Morecambe Offshore Windfarm: Generation Assets Examination Documents

The Applicant's Response to Spirit Energy's Deadline 4 Submission Appendix A: Helicopter Access

Document Reference: 9.59.1

Figure 4.1 Landing Profile

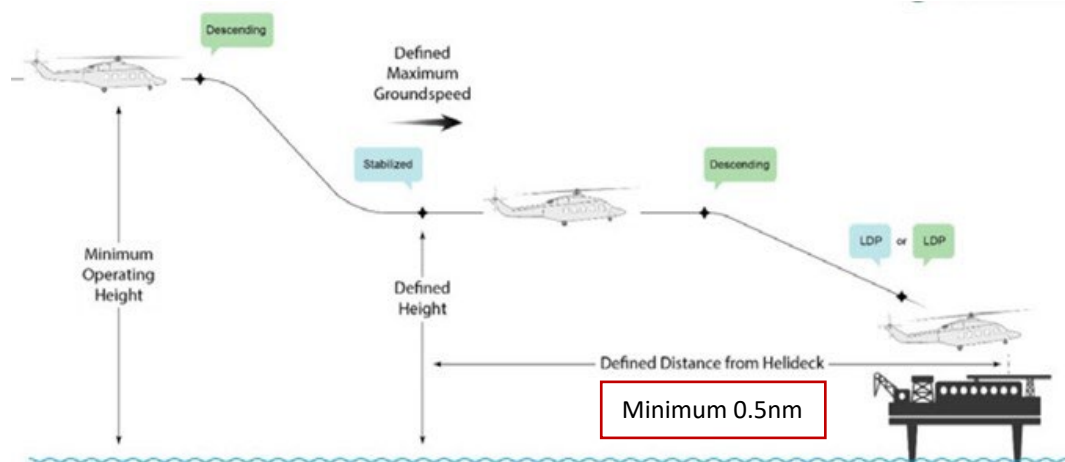
40. Figure 4.1 illustrates the approach path taken, noting that a turn can be made onto the stabilised approach point.

Figure 4.2 AW169 One Engine Inoperative Continued Take-off Profile

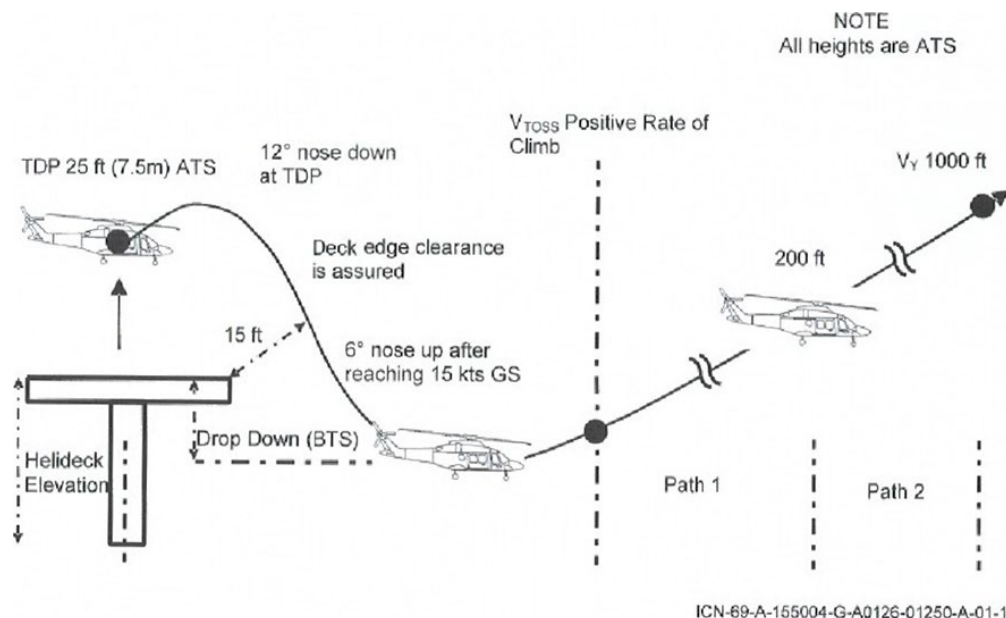
58. Figure 4.2 shows the One Engine Inoperative (OEI) Continued Take-off Profile. It is composed of the following elements:

59. At REP1-116 the Spirit Energy aviation advisors applied the same OEI take-off profile but commenced their turn in VMC at 500ft above helideck height (684ft in the case of CPC-1) or 1,000 ft above helideck height (1,184ft in the case of CPC-1). A height of 684ft during a VMC take-off is not practical as the minimum cloud base under the proposed CAA rule change is 700ft above sea level (currently 600ft), with a vertical clearance from cloud of 100ft necessary to remain VMC. During a meeting on 18 February 2025 between Spirit Energy, their advisor AviateQ and the Applicant, AviateQ stated that they had revised their position. They stated verbally that they had revised their calculations applying all heights above sea level. They have not yet provided any details of their revised calculations. If the profile is not followed and the Flightpath 1 is terminated at 200ft above sea level (16ft above the height of the CPC-1 helideck) and then the level acceleration phase of 0.36nm is also flown at 200ft above sea level, it is not optimising the capability of the AW169 helicopter. Furthermore, it could result in a sustained period of time at 200ft in IMC or at night with an emergency, which is unsafe.

Figure 7.4 Take-off Corridor for CPC-1. Wind Direction 220° with 1nm Lateral Buffer

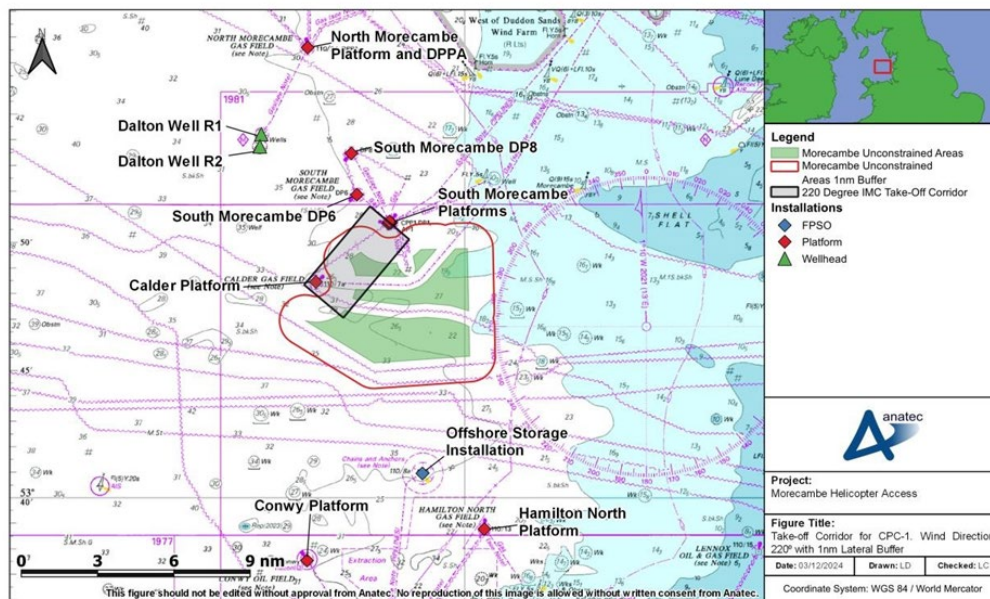
111. If a take-off area from CPC-1 was provided into the prevailing wind, then IMC access for CPC-1 would be increased and the impact on the Morecambe Wind Farm would be reduced, compared to providing a 360° obstacle free area. An example obstacle free corridor with a width of 2nm (1nm either side of a 220° bearing from CPC-1) and a length of 4nm is shown in Figure 7.4. This distance would be sufficient for a one-engine inoperative climb, even taking Spirit's position that 3.76nm is required, as more than 3.76nm will be available, orientated into the prevailing wind.

114. Spirit Energy has calculated an IMC take-off distance of 3.76nm. The IMC Take-off Corridor shown in Figure 7.4 would accommodate their required distance into the prevailing south-westerly wind. Spirit Energy has requested an obstacle free radius of 3.76nm around CPC-1 but this would provide a minor additional benefit as it is uncommon for the wind direction to be southerly when the conditions are IMC or night. Additionally when it is IMC and the wind is northerly, 3.76nm is an insufficient distance for an IMC approach (ARA) as a 9nm obstacle free arc is required to position and then fly the approved profile.

Figure S4-31 DISTANCE REQUIRED for LEVEL ACCELERATION
 from V_{TOSS} V_{BLSS} to V_Y

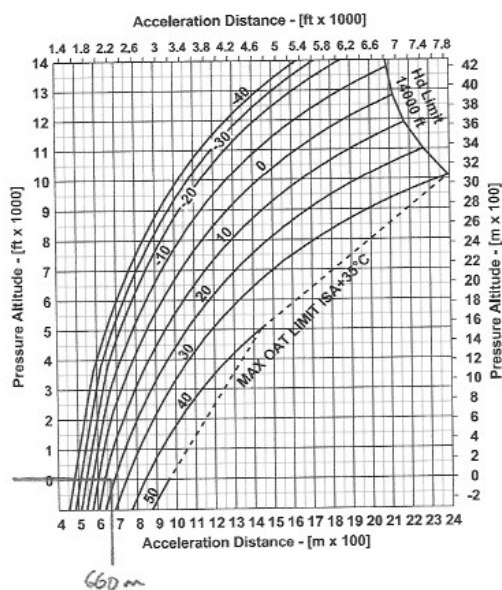
- RFM Figure S4-31 still air distance is 660m (**0.36nm**). However, as wind benefit is permitted for dropdown, Flightpath 1 and Flightpath 2, it is logical to allow it for the level acceleration phase, this is not prohibited by the RFM. Allowing for a 15kt wind at 75kt (Vy) would reduce the distance to 528m (**0.29nm**). Distances for each option are provided (see below where it is stated “*N.B. With wind benefit for the level acceleration phase, this reduces to [...]*”).
